## **ADDENDUM – 2**

November 14, 2024

### **PAWTUCKET HOUSING AUTHORITY Kennedy Manor Waste Pipe Replacements**

**175 Broad Street, Pawtucket, RI 02860**

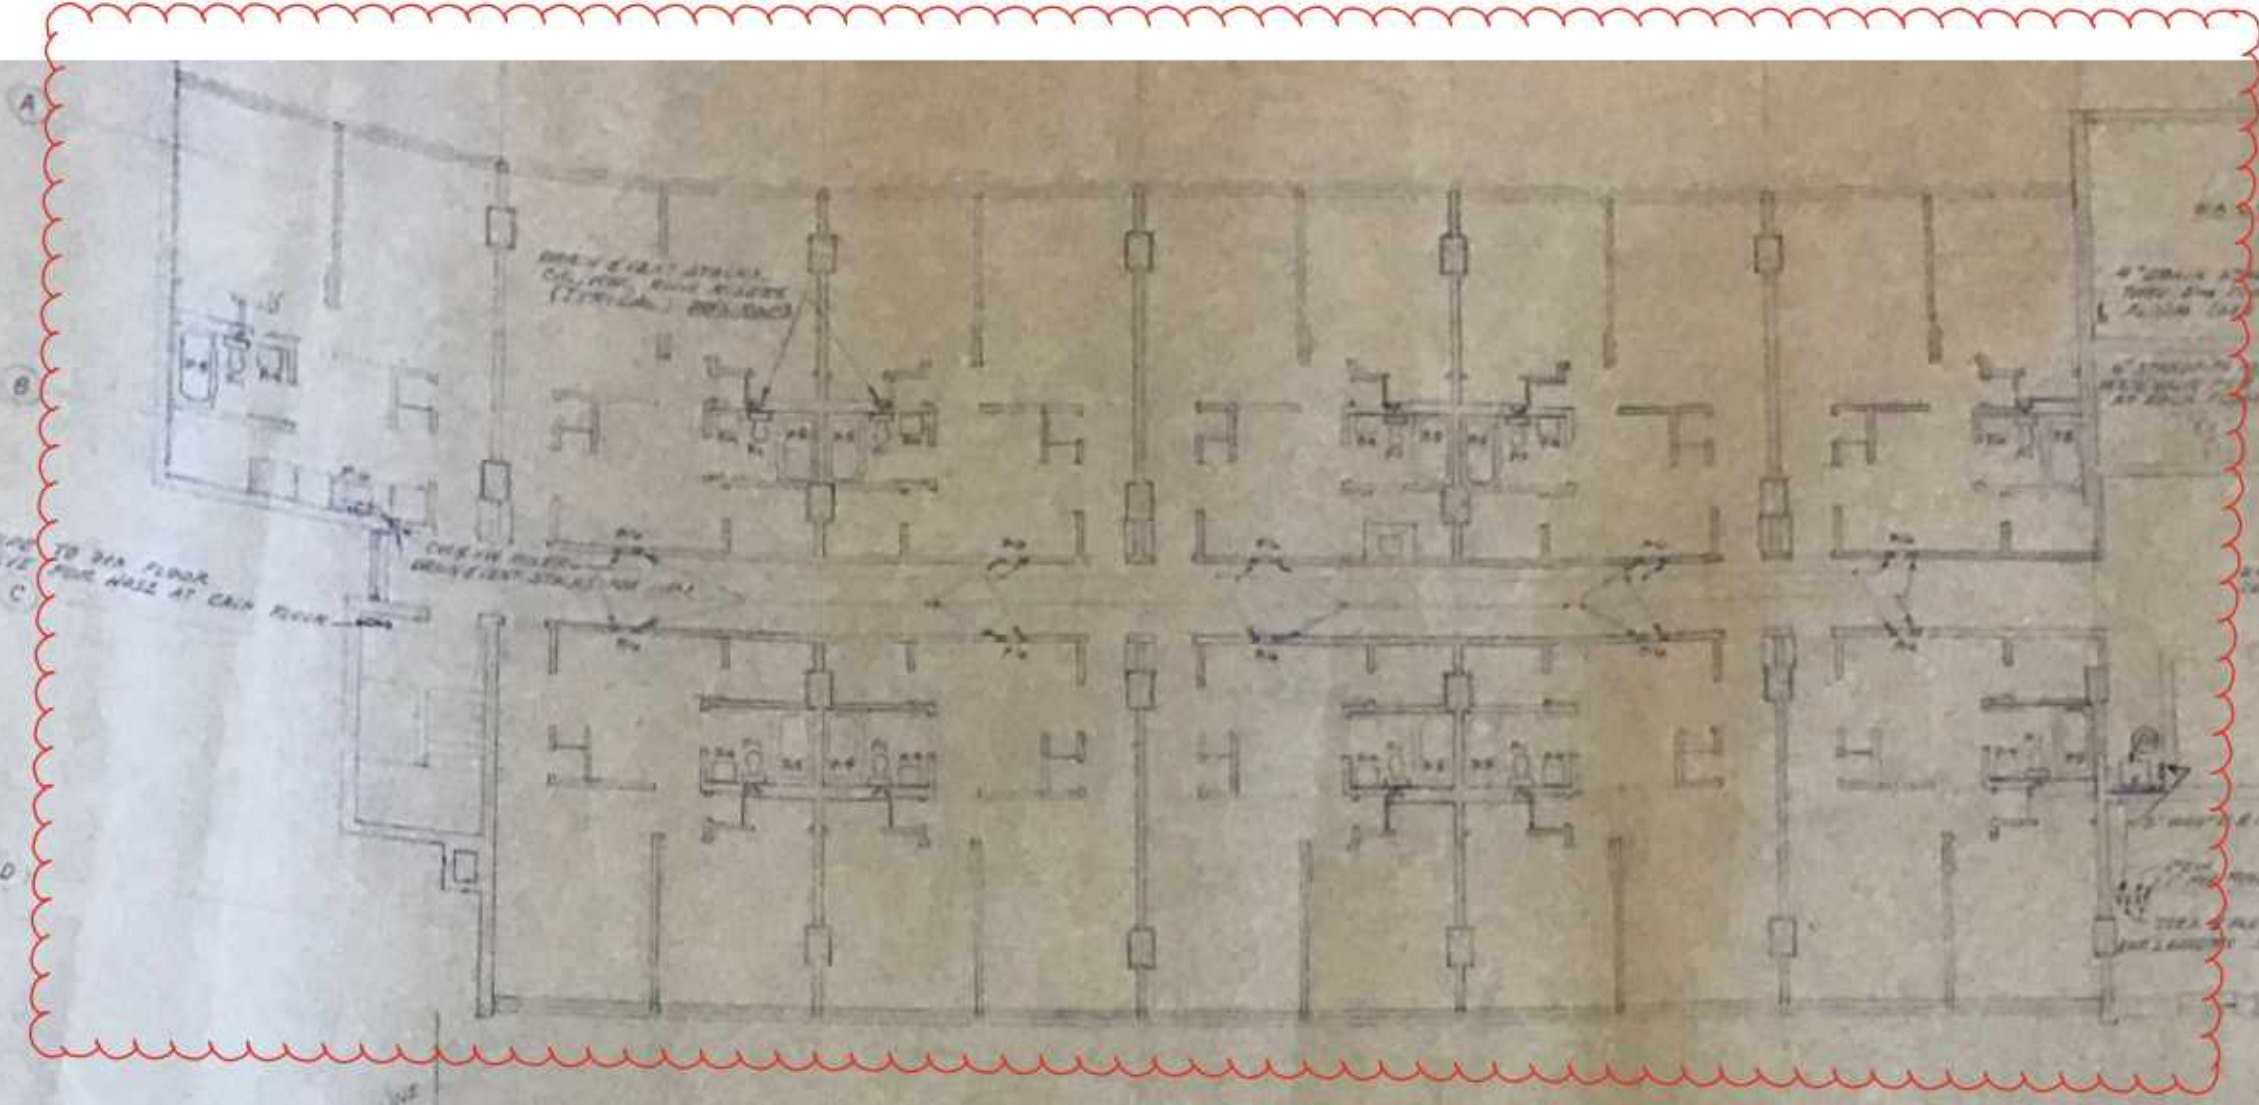
- Item 7: The Pawtucket Housing Authority expanded the existing cut out in the wall to provide additional information. See the attached photograph for reference.

TYPICAL RISER DIAGRAMS

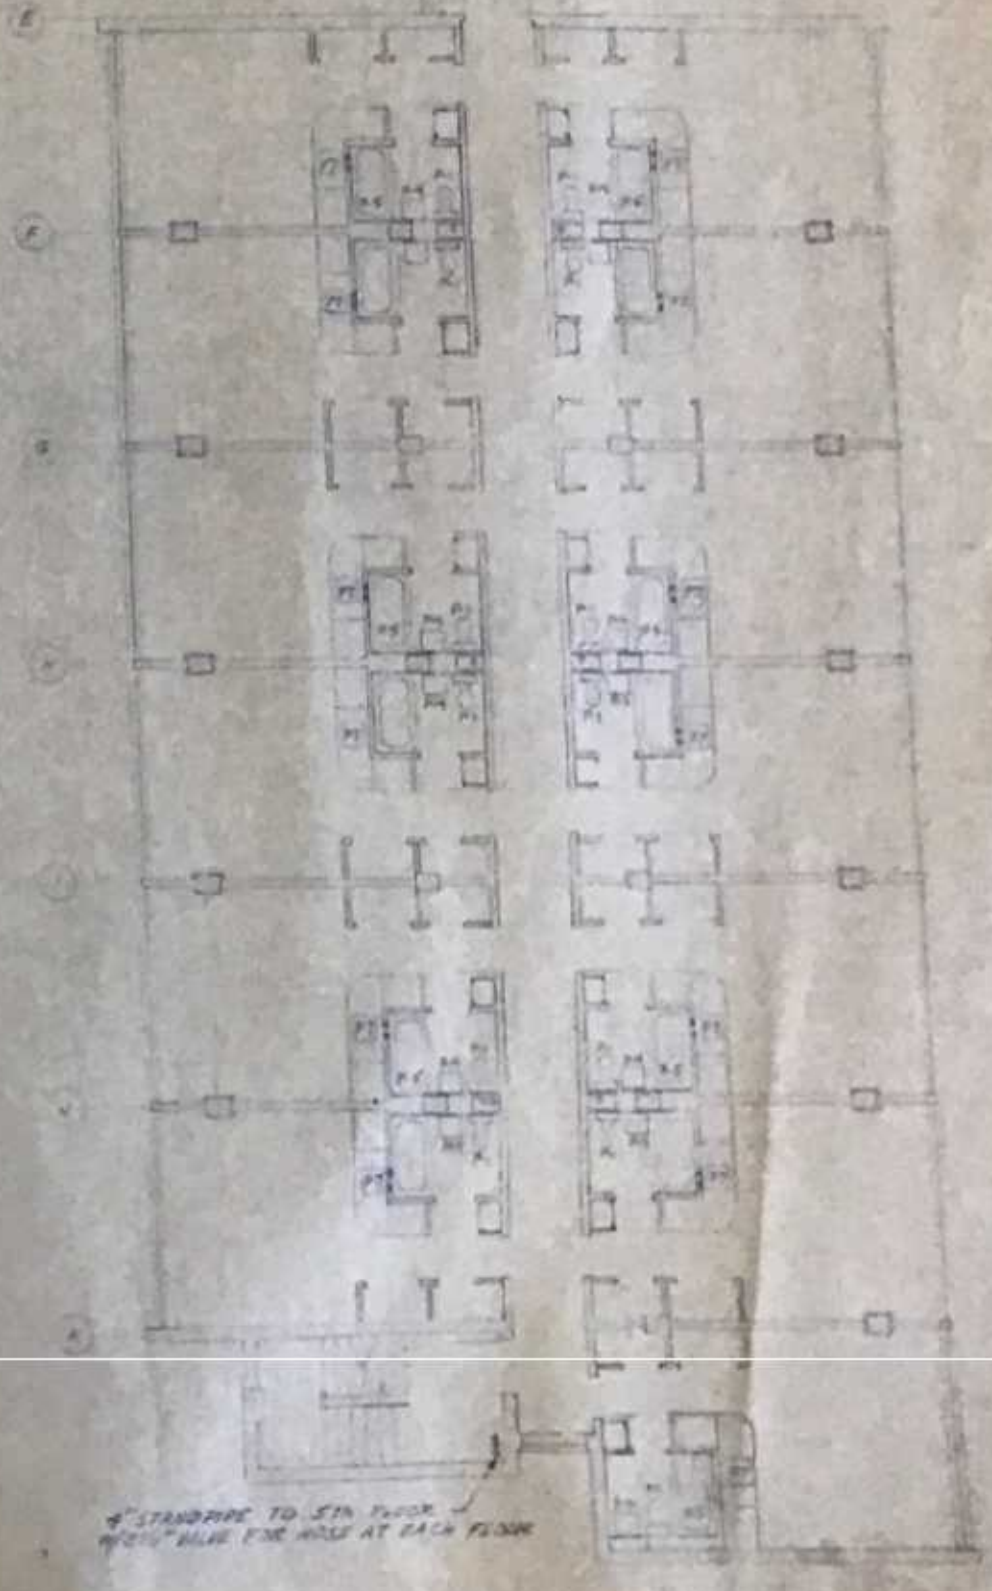
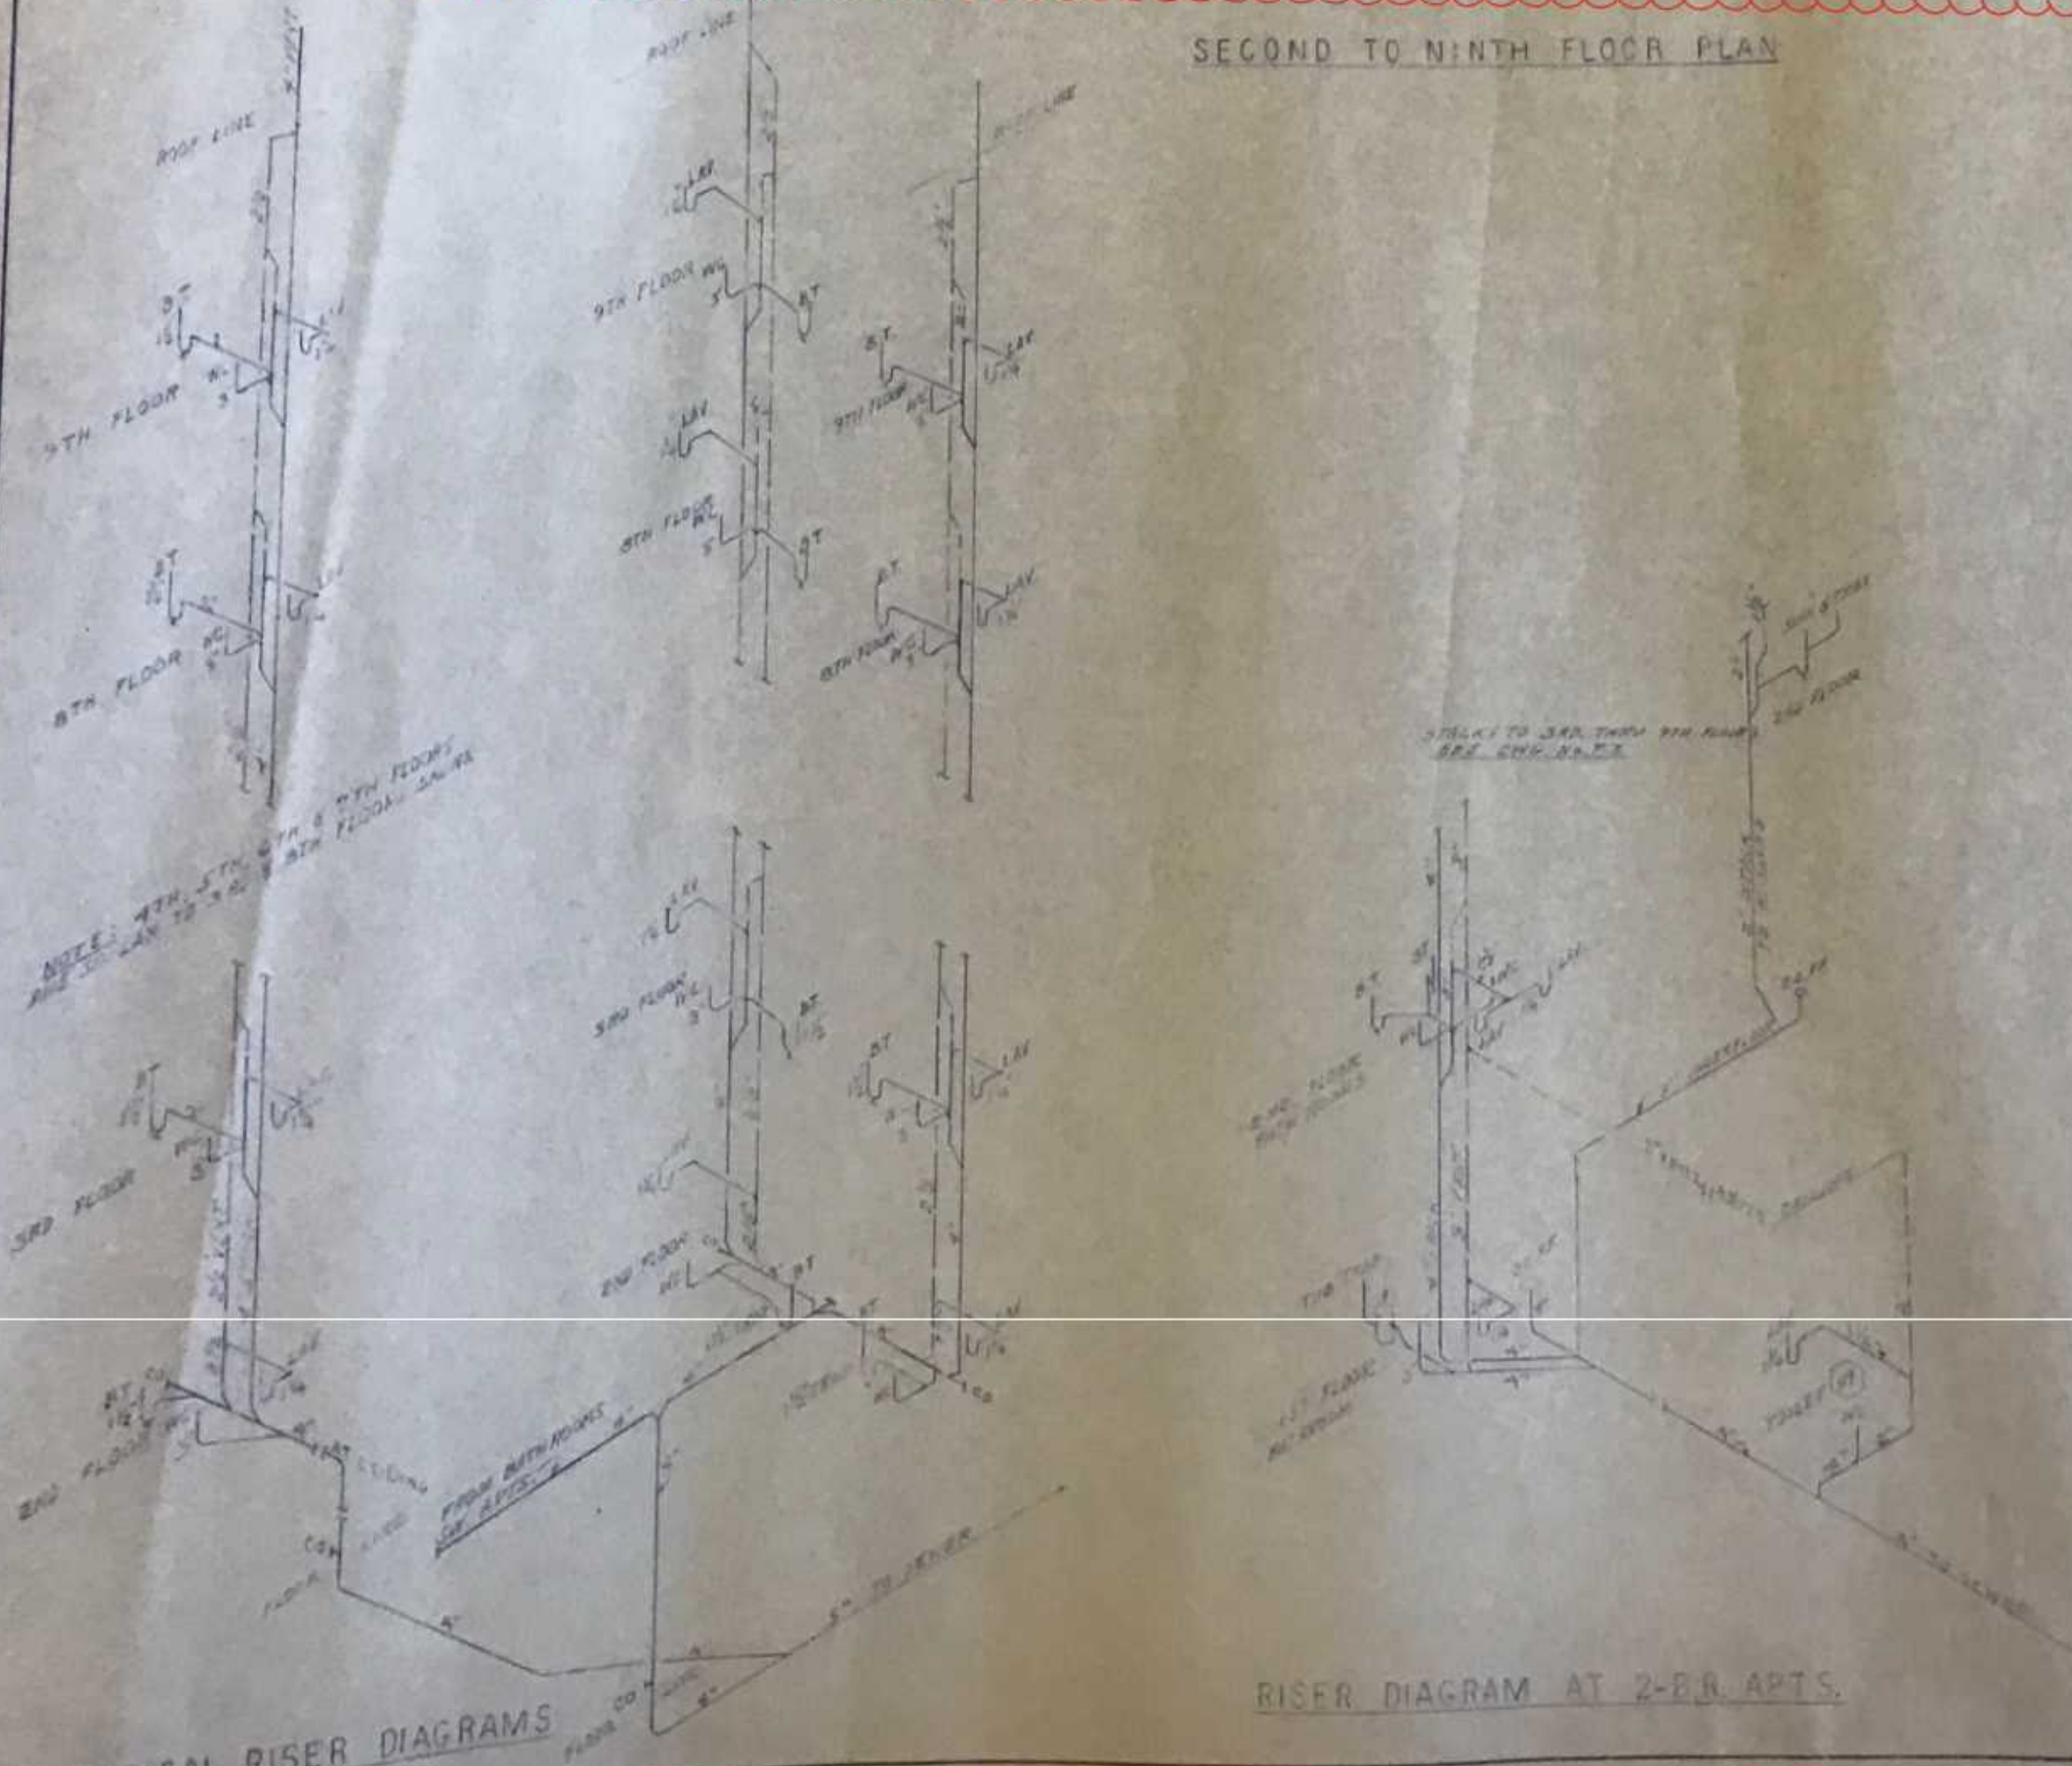
Item 8: The original plumbing riser diagram has been included in this addendum. See attached plan for reference.
